**YESLER TERRACE
BLOCK 5 | BLDG A**

EAST DESIGN REVIEW BOARD

DESIGN RECOMMENDATION MEETING

209 12TH AVE S | PROJECT #3026743

DRB REVISED MASSING

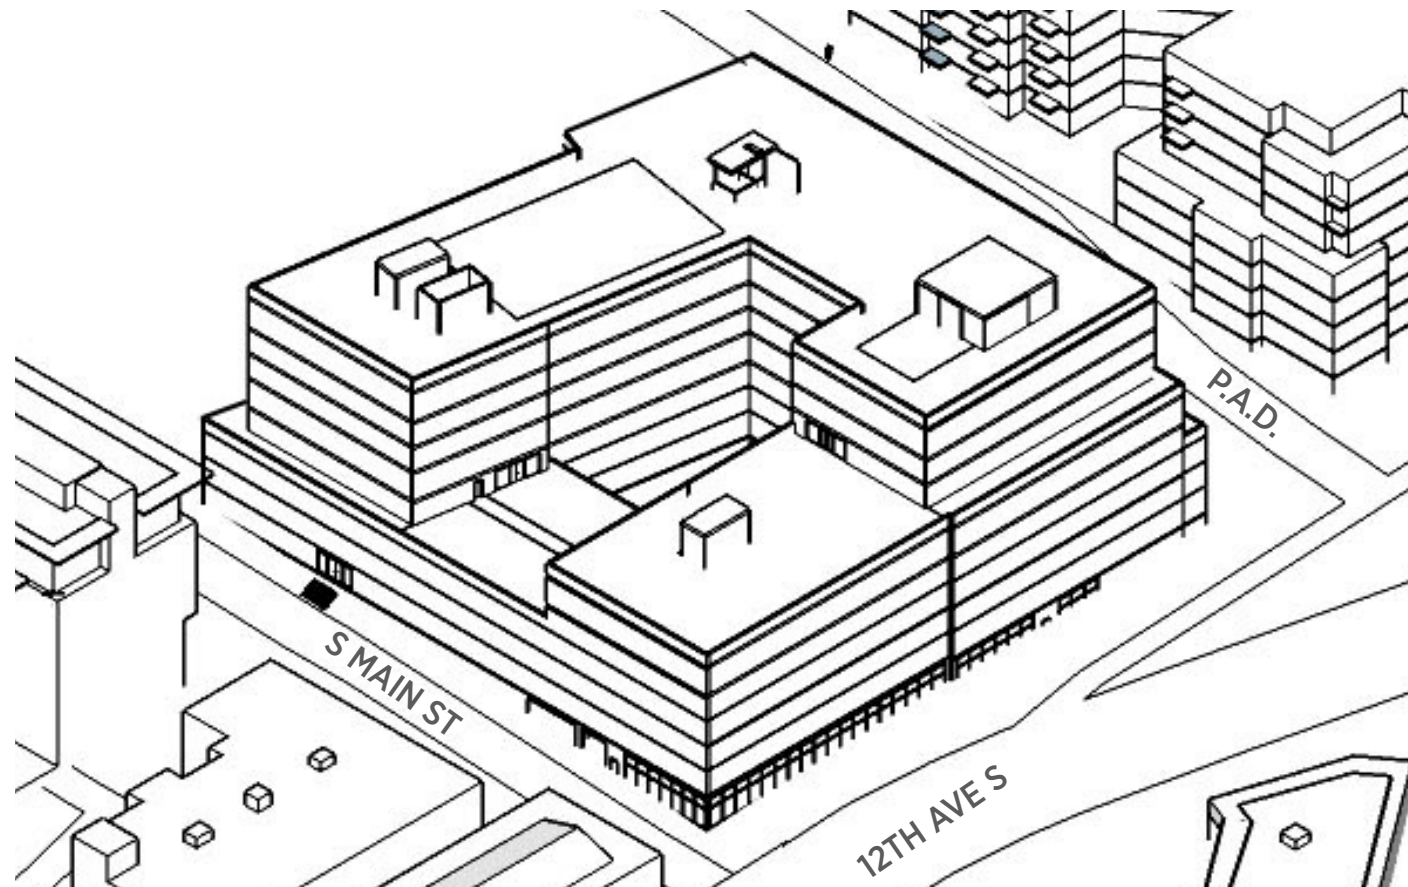
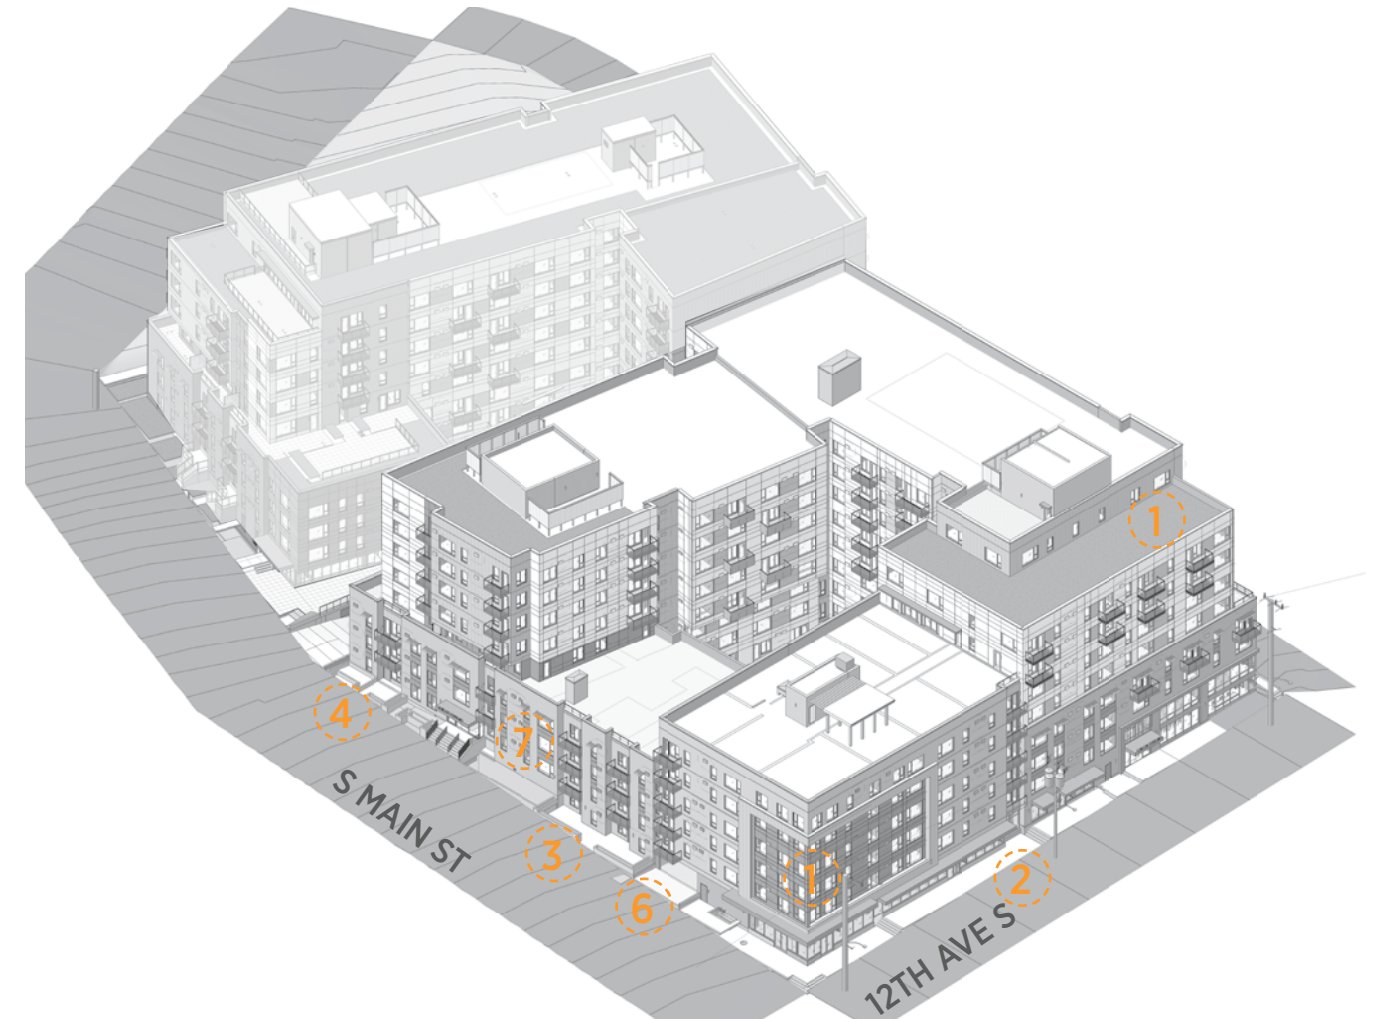
EDG 1 meeting for Building A “the majority of the Board supported Massing Option C for both Phase 1 and 2.” (Buildings A & B)

Both Sites: “The Board approved of the strong proposed street wall articulation but had concerns with how the upper tower volumes met the podium. The Board recommended examining the connection to the base and noted that this condition presented an opportunity to differentiate the two phases, potentially by grounding the tower volume. If the tower volumes remained as an upper massing volume, the Board recommended expanding the height and depth of the upper setback in order to have it be legible from a pedestrian level. (CS2, PL3, DC2)

The tower masses on Building A (Phase I) are consistently treated as an upper massing volume. Where these upper tower masses occur, the towers are set back 7'-0" from the base mass. At the residential lobby entry along 12th, the brick ends at Level 5 and is setback 1' with a change of material to break this mass and continue the brick language around the base. See EDG 1 and revised sections on this page.

At EDG 2 on Building B (Phase II) the massing at the North facade is pushed out and expressed as a vertical element. The revised massing engages to the street level by ‘grounding the tower volume.’ It breaks up the long facade and serves as a hinge-point massing that differentiates the two buildings.

REVISED LOBBY LAYOUT AT DRB - POSSIBLE LAYOUT OPTION ⓘ

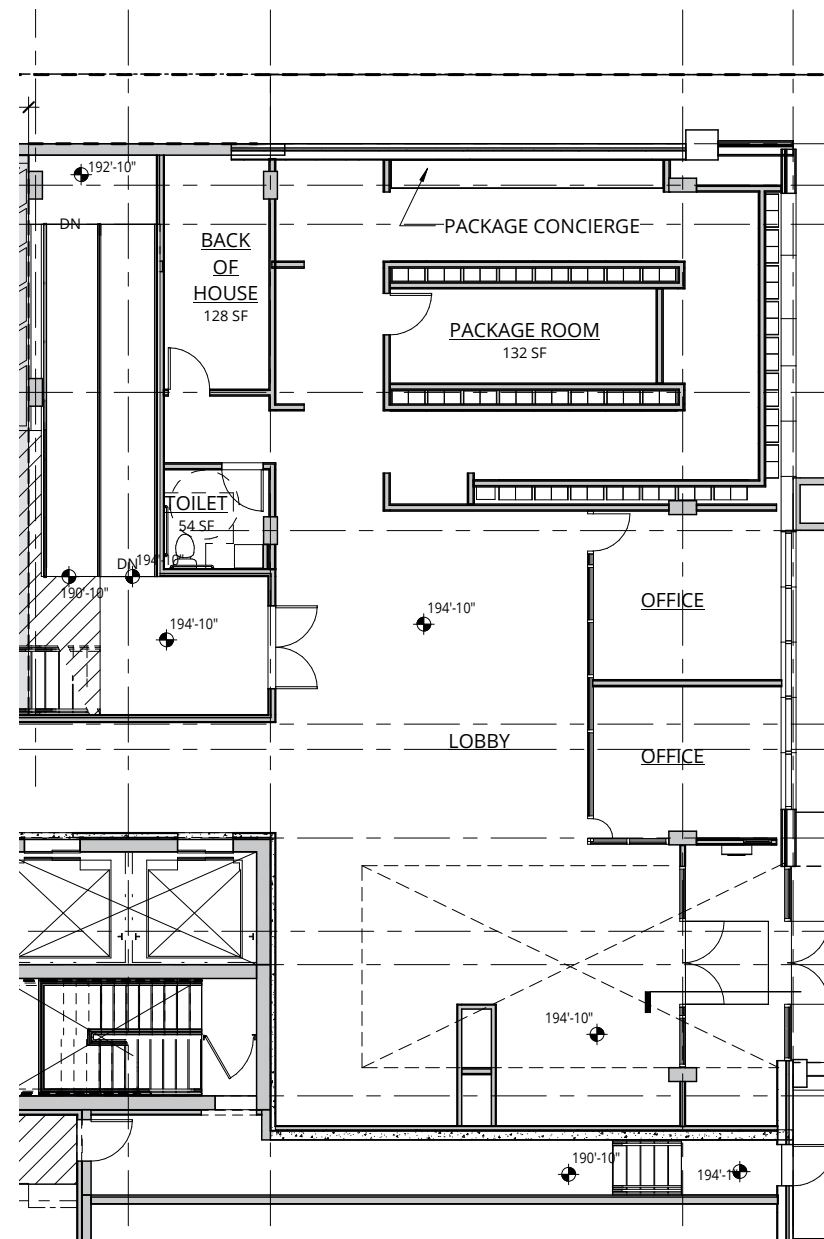
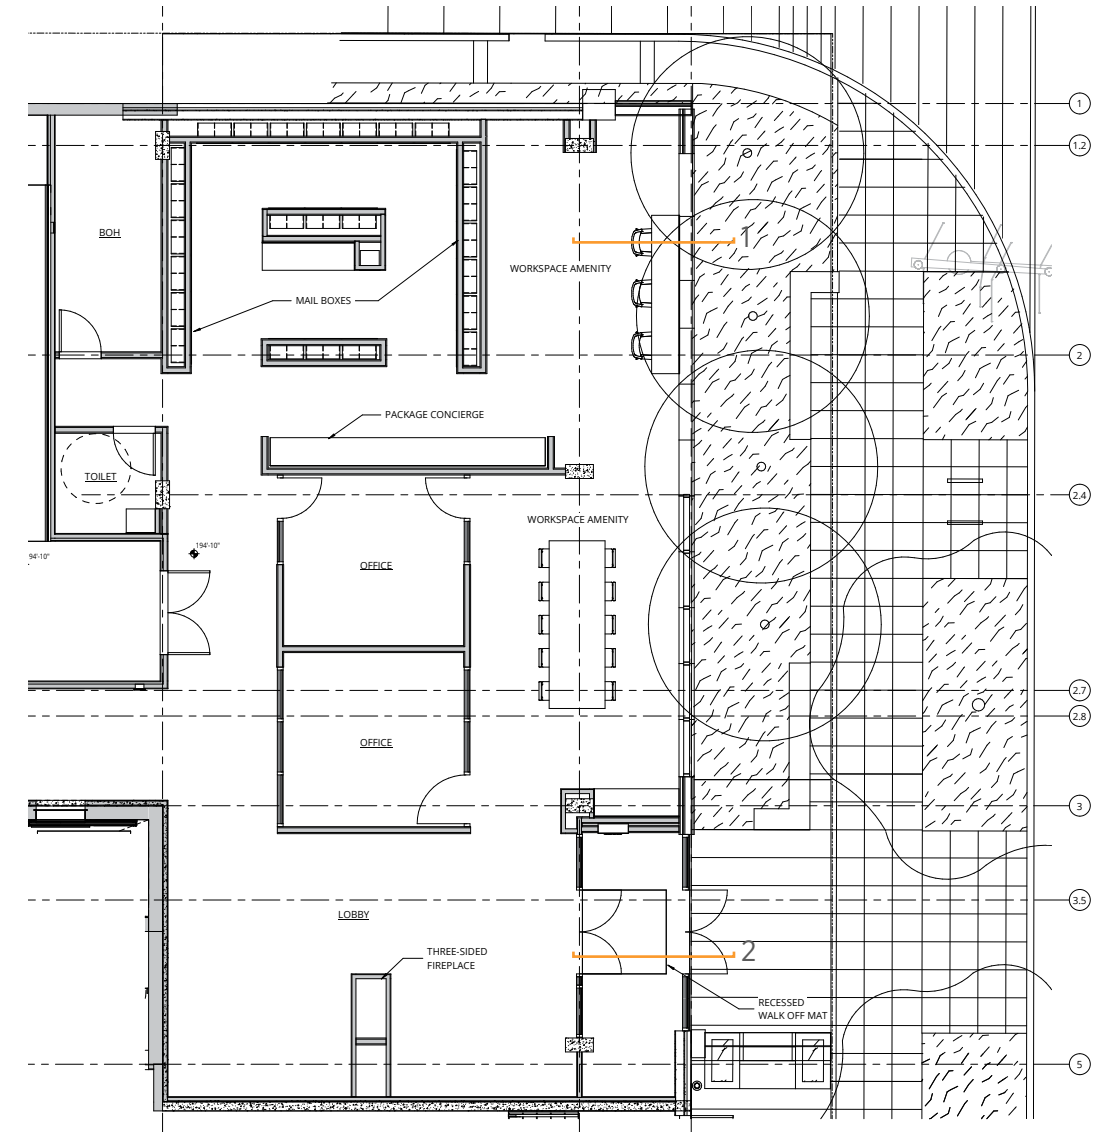
a. Both sites: For the lobby spaces along 12th Ave S and S Main st, the Board recommended minimizing the frontage dedicated to these functions and rearranging the ground floor with more active uses along the street edge.

The ground floor lobby space along 12th Ave in Building A has been redesigned with the more active uses along the street edge. The offices, package room and mailboxes have been pushed towards the back of the space to provide for a more open amenity workspace, Uber waiting areas and gathering space for tenants. This is a suggestion of the active uses that could take place - subject to minor changes as the design progresses but the uses will remain active at the storefront.

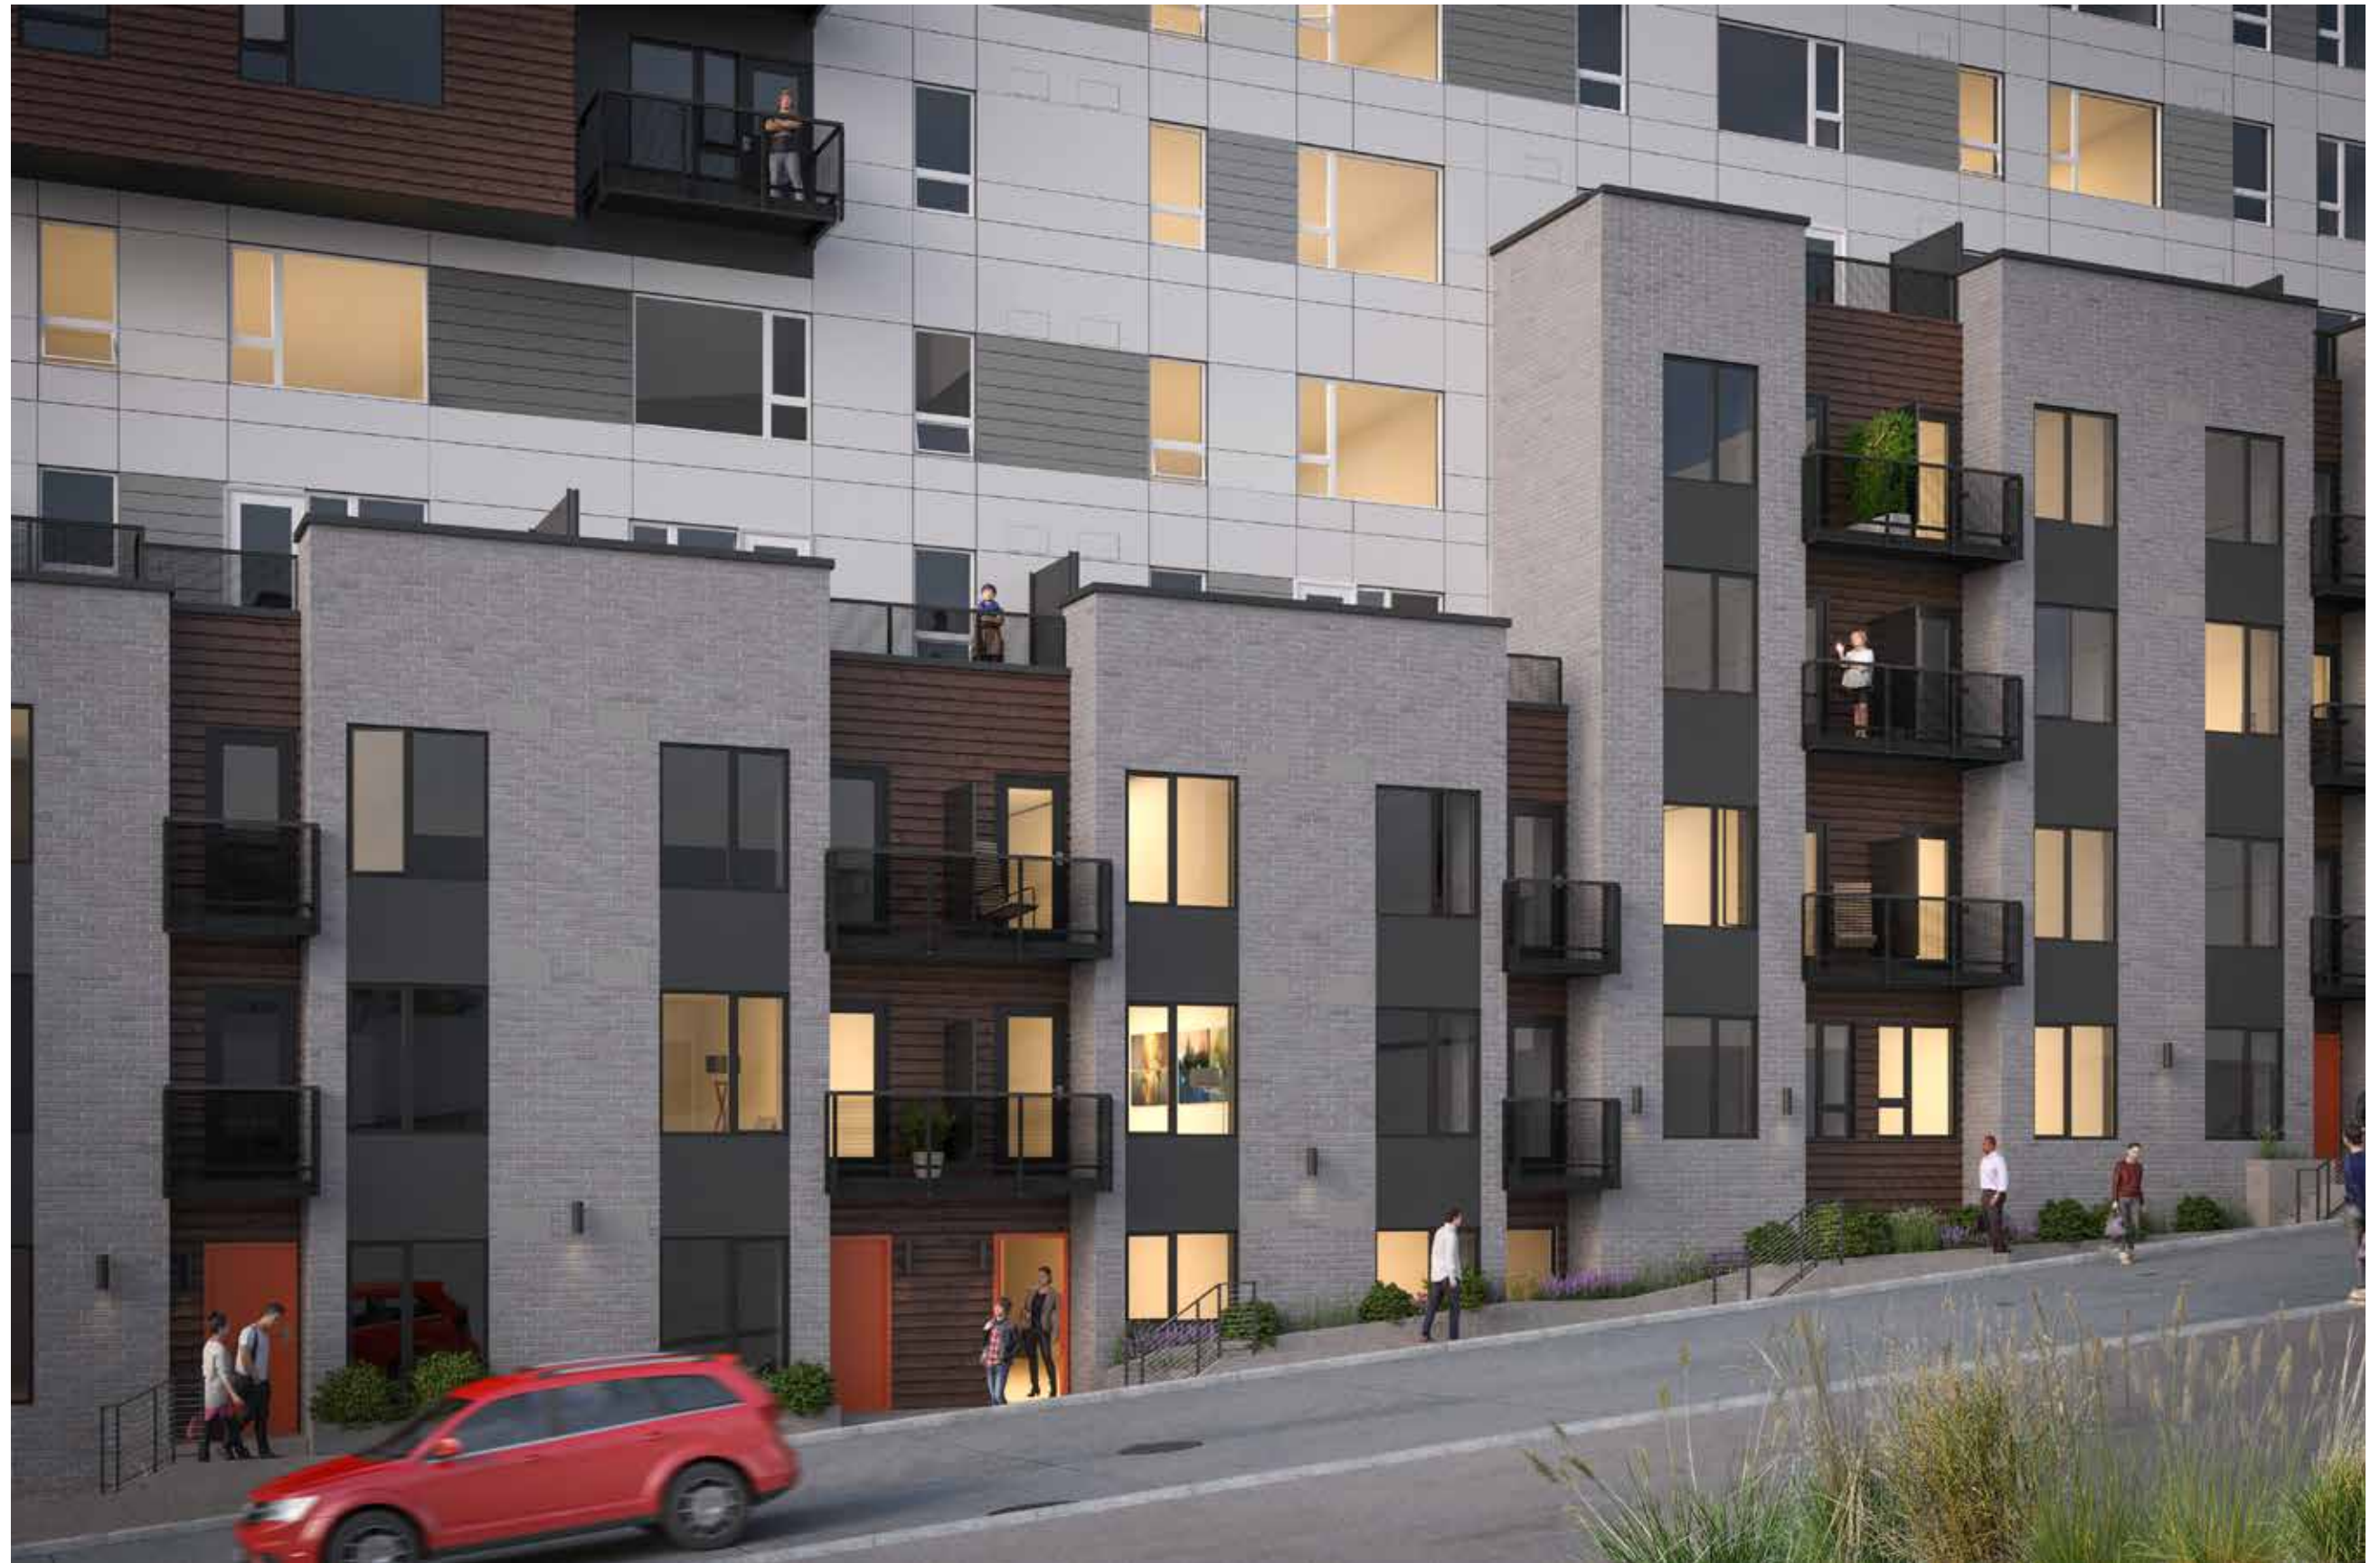
d. EDG 1: Both Phases: The Board stressed the importance of encouraging pedestrian interaction along the access drive and strongly recommended including direct entries or patios buffered from the vehicular area.

c. EDG 2: For the access drive frontage, the Board strongly supported the proposed alternate with direct entries and shared circulation space, referred to as the “stoop walk.”

As discussed in EDG 2, the “stoop walk” has been continued along the Access Drive at Building A. The residential entries along the stoop walk have been maximized, with 5 entries spread across the Building A Access Drive frontage. There will be several points of pedestrian access onto the stoop walk based on the topography.

The stepping walkway mitigates the slope and is accessible by the public. The planters, stoops and the 3' stepping walkway provide a nice transition from private to public area. Residential entries are setting back an additional 3' from the face of building to enhance the transition.

DEPARTURE
UNIT PATIO SECTION @ MAIN ST

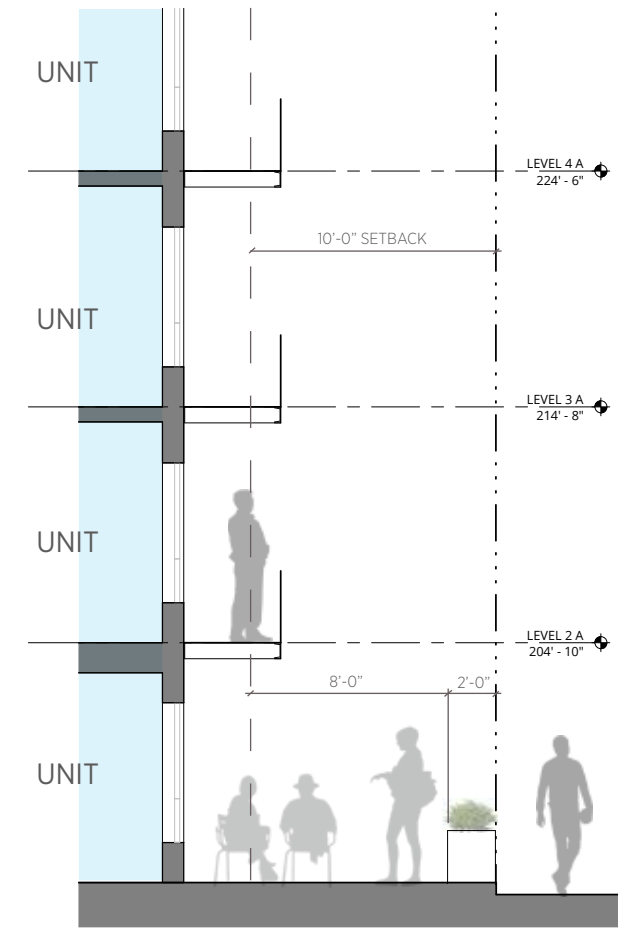
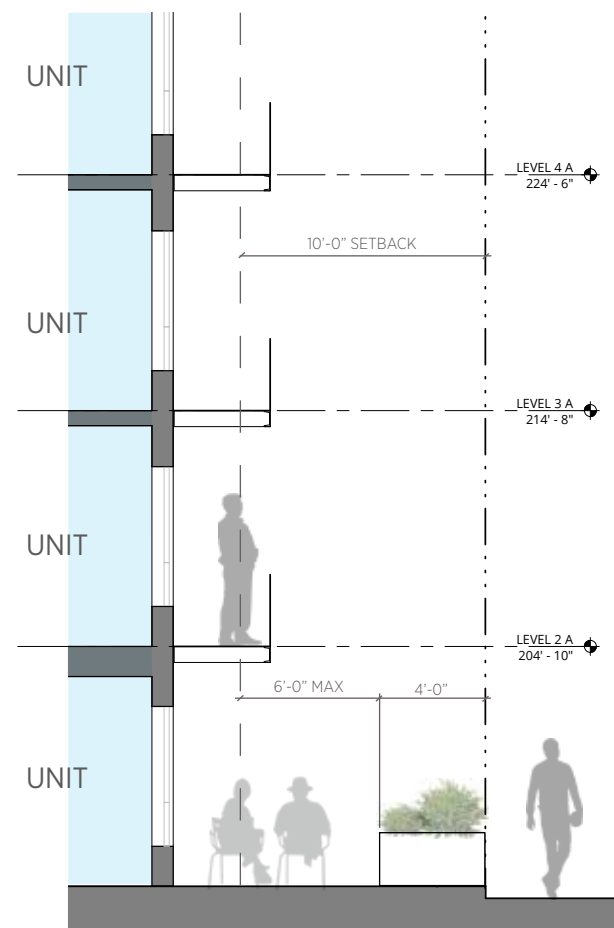
Provide patios for residential access which project beyond 6 feet into the required setback. Edge of patios are 2ft minimum away from a boundary line. The departure request occurs at the ground level patios along the South facade, Main St.

Extending the edge of patios and decks from 6 ft. maximum into the setback to 8' into the setback will better promote safety and security at street level, by providing "eyes on the street" closer to the sidewalk.

The extended decks encourage use of the deck areas by providing more usable area to residents, which will help in activating the street level and providing interaction with the sidewalk. The layered transition from private to public spaces is consistent with the building-open space relationship in the design guidelines. The sidewalk environment will be more lively and safe. The following design guidelines will be enhanced:
